30 – 46 Auburn Road, Regents Park Planning Proposal

Submissions Report

Submitted to Sydney South Regional Planning Panel

Figure 2: Exhibited height of buildings map (Source: Planning Proposal)

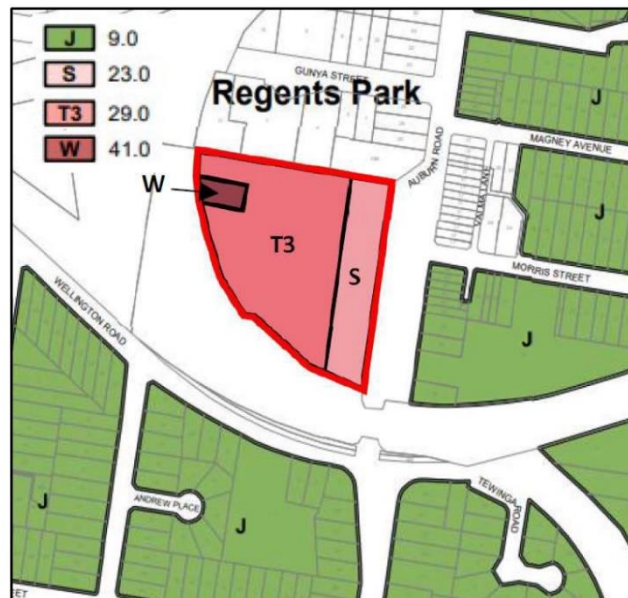
The applicant contends the proposed maximum height of building map (Figure 2) is very prescriptive in the exact location of the 41 metre height limit to support the 12 storey building and does not provide the flexibility required when designing the building, including where there may be small variations in the exact location and dimensions of the building.

The applicant's revised position is a significant deviation from the exhibited height of building map and would change the arrangement of buildings. The applicant's height has not been tested as outlined with the current proposal. It would allow for a built form on the site that the community and Council were not informed of during the public exhibition.

It is recommended that the applicant's position not be supported as it would result in a significant deviation from what was exhibited and is not substantiated by evidence. If the applicant were to pursue any development of the site within the controls outlined in the planning proposal, any exceedances should be dealt with through the relevant planning mechanism, that being a 4.6 application and assessed on their merits, or another planning proposal.

Figure 3: Applicant's proposed height of building map

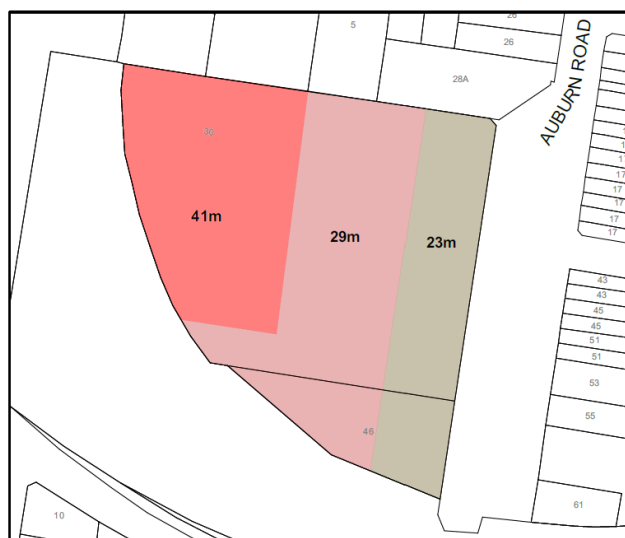
The applicant states that additional heights would allow built form to be more appropriately dispersed across the site leading to significant improvements in solar access and amenity for the apartments and central communal open space. The applicant seeks a post exhibition alteration to amend the height of building map to get the right outcome for buildings within the 41 metre (12 storey) height, while remaining consistent with the wording of the Gateway determination that requires the 41 metre height limit to be located within the north-west corner (see Figure 3).

The heights within the exhibited planning proposal are reflective of the outcomes expressed within the NSW Independent Planning Commission's review and the applicant has had considerable opportunity to raise any concerns prior to exhibition. A significant post-exhibition alteration, which this would be, is not equitable to the community and if supported, should require re-exhibition.
